Zaporizhzhya NPP and South-Ukraine NPP

Rivne NPP

**ANSWERS TO THE QUESTIONS OF THE REPUBLIC OF AUSTRIA AS A PARTY
REGARDING EXTENSION OF THE LIFETIME OF RIVNE NPP 1 AND 2**

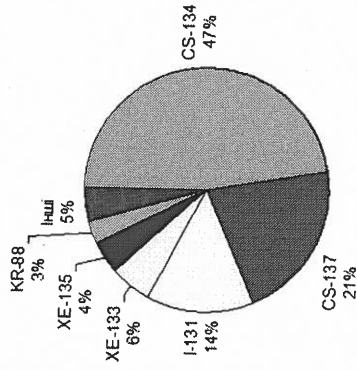
№ з/п	Розділ/пункт	Коментар зачепленої сторони англійською / українською	Відповідь на коментар українською / англійською
AU21	Question 5 Питання 5	What is the technical justification of the BDBA that is chosen to calculate possible trans-boundary consequences?	<p>When determining the radionuclide release during the beyond design basis accident (BDBA), the limit value of Cs-137 release into the environment at the level of 30 TBq was taken as the basis, in accordance with the safety requirements of European operating organizations for designs of nuclear power plant with light-water reactors. The Cs-137 isotope was chosen because of its dominant importance for long-term environmental contamination, as well as its effect on the health consequences.</p> <p>Other isotopes in the form of aerosols (that is, all radioactive decay products, except for noble gases and gaseous isotopes of iodine) are released into the environment in proportion to this value, even if these isotopes are released into the atmosphere.</p> <p>For noble gases and gaseous forms of iodine, the activity of release was calculated at the level of 0.5% of all activity in the containment per day. The total release activity over the entire release period was conservatively set at level of 7-times release activity during the first day.</p> <p>The height of release is conservatively considered as near-surface, which corresponds to the predicted release routes in case of serious accidents due to leakage of containment.</p> <p>Into the general list of radionuclides that can enter the environment, in addition to the isotopes taken as an example, other radioisotopes from the same group are added, and they are represented in a common term in the same ratio as in the aggregate of decay products in the reactor core, relative to isotope taken as an example.</p> <p>When calculating the dose of the proposed source member, it is recommended to take into account the release of individual radioisotopes, in accordance with a time interval of linear duration from 0 to 24 hours after the accident, which is a conservative approach compared with the considered release duration of 7 days.</p> <p>Table. 3.5 (Book 7, “Transboundary environmental impact of production activities”) provides the parameters for the release of radionuclides during the maximum design basis accident. The duration of this accident is assumed to be 60 minutes. All other accidents leading to lower releases of radionuclides are not considered.</p>

The main radionuclides and their release during the beyond design basis accident are given in table. 3.6. (Book 7 "Transboundary environmental impact of production activities").
 Table 3.6 - Activity of radionuclides releases during the beyond design basis accident at RNPP, Bq

Also, the contribution of Xe-135, Xe-137 was calculated and shown, and the corresponding conclusions were drawn. The expected effective doses for the population after MDBA and BDBA are small compared to the natural radiation background. According to the report of the UN Scientific Committee on the effects of atomic radiation presented to the UN General Assembly for 1993, the annual effective dose from natural sources of radiation in areas with normal radiation background is 2.4 mSv, that is, over 50 years, this dose will be 120 mSv. And during BDBA the expected dose over 50 years is less than 13 mSv for all countries.

The relative contribution of various nuclides to the expected effective dose at a distance of 340 km from the RNPP during BDBA is shown in the diagram below.

<p data-bbox="657 91 751 1518">As follows from the data on the diagram, the largest contributions are made by cesium isotopes: 134Cs - 47% and 137Cs - 21%. Inert gases: 133Xe, 135Xe and 88Kr also make a noticeable contribution to the total effective dose. The total contribution of the remaining 29 nuclides during BDBA is less than 5%.</p>	Ізотоп	Відсоток	CS-134	47%	I-131	14%	CS-137	21%	XE-133	6%	XE-135	4%	KR-88	3%	Інші	5%
Ізотоп	Відсоток																		
CS-134	47%																		
I-131	14%																		
CS-137	21%																		
XE-133	6%																		
XE-135	4%																		
KR-88	3%																		
Інші	5%																		
	6 ACCIDENTS INITIATED BY NATURAL EVENTS AND SITE ASSESSMENT 6 АВАРІЇ, ПІНЦЬОВАНІ ПРИРОДНИМИ ПОДІЯМИ, ТА ОЦІНКА МАЙДАНЧИКА		<p data-bbox="842 1099 866 1368" style="text-align: center;">General information regarding analysis of the accident caused by natural events and site assessment</p> <p data-bbox="866 91 1034 1518">As the EIA report was prepared in 2018, it used the actual results of the probabilistic safety assessment (PSA) for RNPP units 1&2 as of 31.03.2014. Within the current periodical safety review for units 1&2 the PSA and SF-6,7 of the periodical safety review reports were updated as of 01.07.2018. The updated materials contain a much wider list of external hazards that were subject to safety impact review, and account for upgrading measures implemented at units 1&2 as of 01.07.2018, including the measures developed based on the lessons learnt from the Fukushima accident.</p> <p data-bbox="1034 1384 1058 1518">Documents:</p> <ol data-bbox="1058 91 1249 1518" style="list-style-type: none"> 22.1.133.OB.04.10.Rev.1. Rivne NPP. Unit 1. Safety analysis report. Probabilistic safety assessment. Annex X. External hazards. 2020. 22.1.133.OB.12.03.Rev.1. Rivne NPP. Unit 1. Safety analysis report. Probabilistic safety assessment. PSA update report. 2020. <p data-bbox="1249 91 1417 1518">22.1.133.OPPB.02.03. Rivne NPP. Unit 1. Periodical safety review report, Safety factor 7. Chapter 2. Unit safety analysis. PART 3. Analysis of safety impact from internal and external events. 2020</p> <p data-bbox="1417 91 1465 1518">Floods caused by extreme precipitations have been analyzed in the PSA. Based on the analysis results it was defined that heavy rains may result in malfunction of the open switchyard equipment and other normal power supply system equipment that may cause initiating events of the group "Loss of all 6 kV house loads power supply buses" that is considered in the Level 1 PSA for internal initiating events. This group covers, in particular, events associated with the loss of external (open switchyard and the grid) and internal initiating supply sources of the unit. In IE frequency determination for the Level 1 PSA for internal events based on statistics of actual operational occurrences various initiators were accounted for including the IE caused by external factors. The IE group "Loss of all 6 kV house</p>																
AU22	Question 1 Питання 1	Why has flooding due to extreme precipitation been excluded from the further consideration of natural hazards?
